20023-01-001

**Proposed Residential Development at
R510, Raheen, Limerick**

ROAD SAFETY AUDIT STAGE 1 / 2

March 2020

2.1 Problem

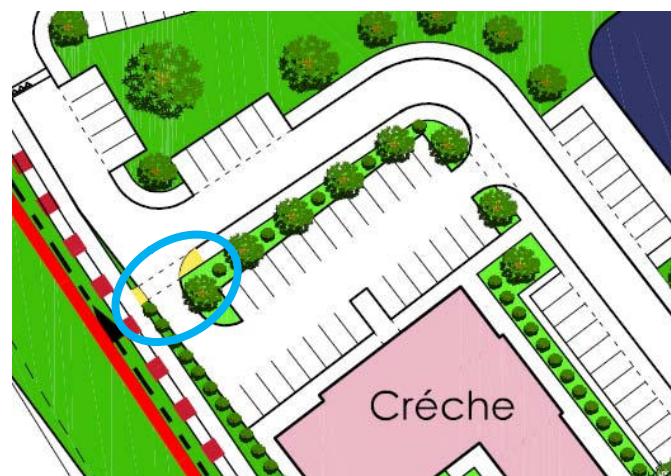
Stopping sight distance for drivers of vehicles on the approach to the proposed roundabout from the development may be restricted by the proposed vegetation on the southern side of the proposed access road. A lack of adequate stopping sight distance at the proposed access may contribute to a rear end collision at the roundabout exit.

Recommendation

Omit the vegetation so as to provide adequate stopping sight distance on approach to the proposed roundabout.

2.1	yes	no	Proposed hedging to be low level (<0.9m height). Tree to be set back clear of approach sight line.	YES
2.2	yes	yes	—	—
2.3	yes	yes	Shared surface is proposed to encourage a low speed zone. Ramps at the entrance and contrasting colour tarmac proposed. Yield lines to be introduced, see attached 18112-C13-C Footpath along main thru road running west-east.	—

2.6 Problem

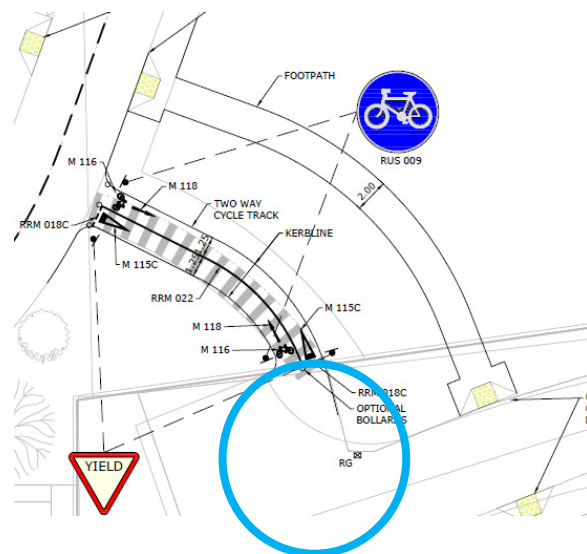
The most direct route from the proposed development access to houses at the northern end of the development is via an area of shared surface at the apartment blocks. This will result in a significant amount of vehicular

movement along this section of the shared surface. A shared surface may not be suitable along this section of the access road.

Either provide a separate footpath along this section of the shared road to ensure the safety of pedestrians is catered for or revise the layout to prevent vehicles from travelling through this area.

2.5	yes	yes	—	—
2.6	yes	yes	Shared surface is proposed to encourage a low speed zone. Ramps at the entrance and contrasting colour tarmac proposed. The road width on approach to shared area to be reduced to 5.5m to encourage low approach speed. Pedestrian footpath provided through this section.	—

2.8 Problem

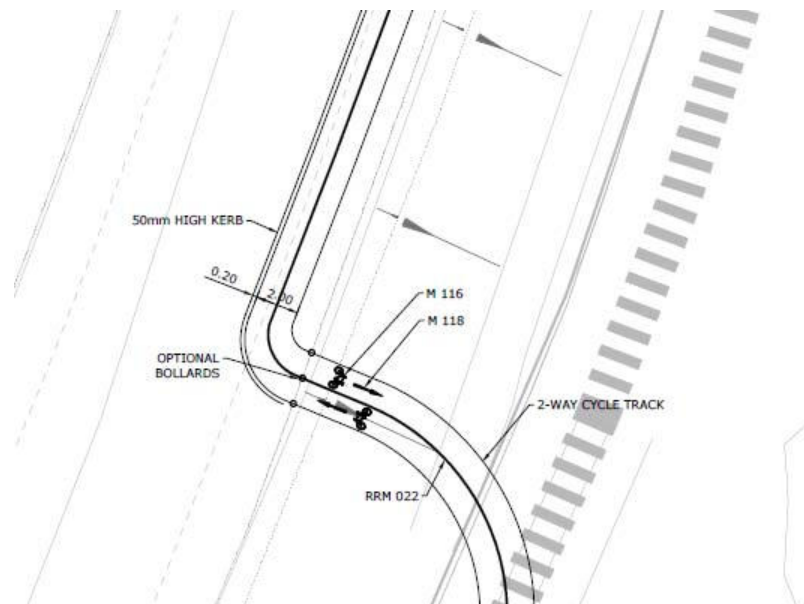
Street lighting exists along the public road. However, street lighting is not shown to be provided within the proposed development. Road safety would be enhanced with the provision of street lighting.

Provide adequate street within the proposed development.

2.7	yes	yes	—	—
2.8	yes	yes	—	—
2.9	no	no	The proposed connection is in accordance with the discussions with LCCC. Proposal is to provide a two-way cycleway along the hard shoulder of the	YES

2.10 Problem

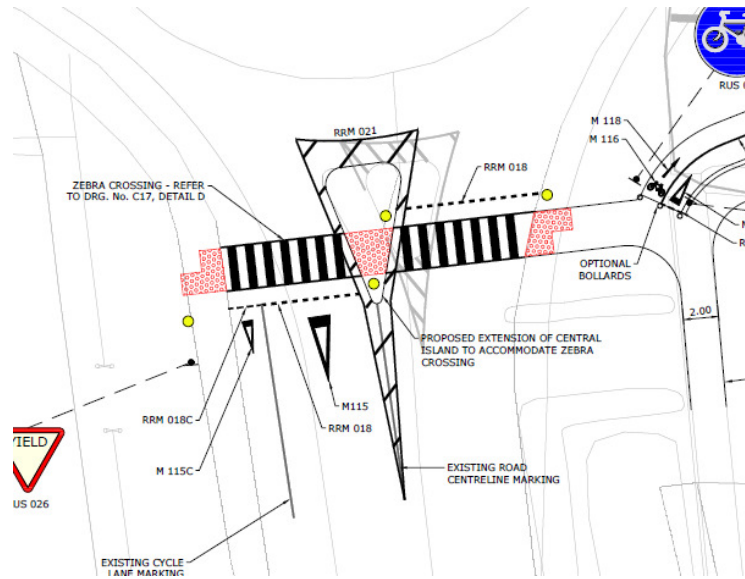
The proposed cycle layout on the southern arm of the roundabout at the development access may not safely cater for cyclists wishing to access or exit the proposed development. A lack of an appropriate cycle access to and from the development may contribute to a collision at this location.

Provide appropriate cycle connections between the cycle facility within the proposed development and the existing northbound cycle lane and south hardshoulder on the R510.

R510 that will connect to existing cycle infrastructure at the roundabout to the north. The cycleway is to be separated from vehicular traffic by a 50mm high kerb. Expansion of the lanes to include a footpath is problematic due to the intersection with the CIE rail line and other land ownership issues. However the re-routing into part of the site is a long term proposal to provide more amenity on the cycle lane and fully break from the traffic.	
2.10	yes	yes	Two way cycleway through the site is proposed for north and south bound traffic. Northbound cyclists can either go around the roundabout or dismount and access footpath and zebra crossing via dropped kerb. Southbound cyclists are now provided with a link to the existing hard shoulder to the south of the roundabout.	
2.11	yes	yes

2.11 Problem

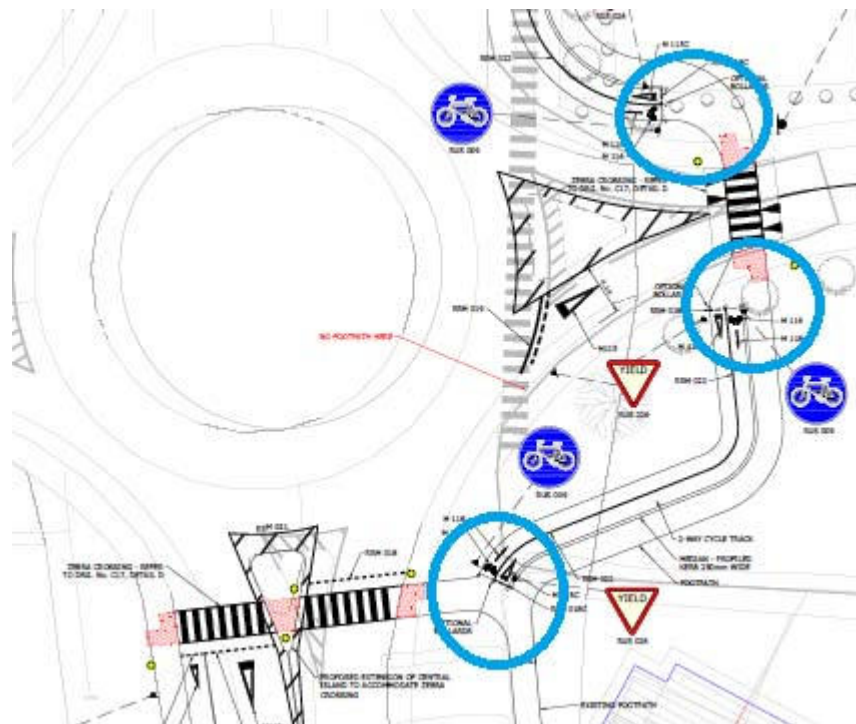
There are a number of conflict points between pedestrians and cyclists at the proposed zebra crossings. A lack of adequate guidance may contribute to a pedestrian/cycle collision at these locations.

Provide appropriate corduroy paving on the pedestrian and cycle approaches to the conflict points to reduce the risk of a pedestrian/cycle collision.

2.13 Problem

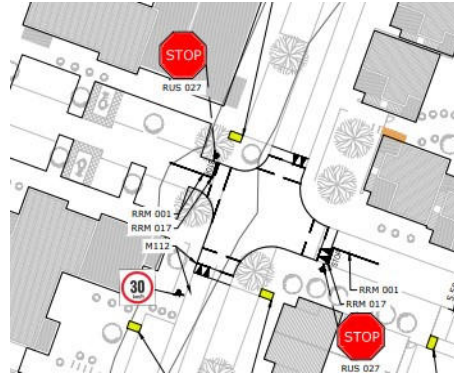
There are a number of locations throughout the development where there appears to be obstructions located within the proposed footpaths restricting the available width for pedestrians. In addition, there also appears to be some locations where adequate footpath linkage is not provided. As a result, pedestrians may be forced to step off the footpath onto the carriageway where they would be at an increased risk of being struck by passing vehicles.

Ensure that adequate footpath width is provided throughout the proposed development and that adequate footpath connections are provided to all locations within the proposed development.

HOM Response: Please note that landscaping obstructions have been removed, and where present, are separated from the footpath allowing adequate space for passing / turning etc. Please refer to revised Road Markings & Signage drawing 18112_C13_Rev K enclosed. In relation to the footpath connections, it has been the objective of the Designer to provide all footpath crossings necessary. Where this is not present, it shall be rectified until satisfactory crossing is provided where applicable.
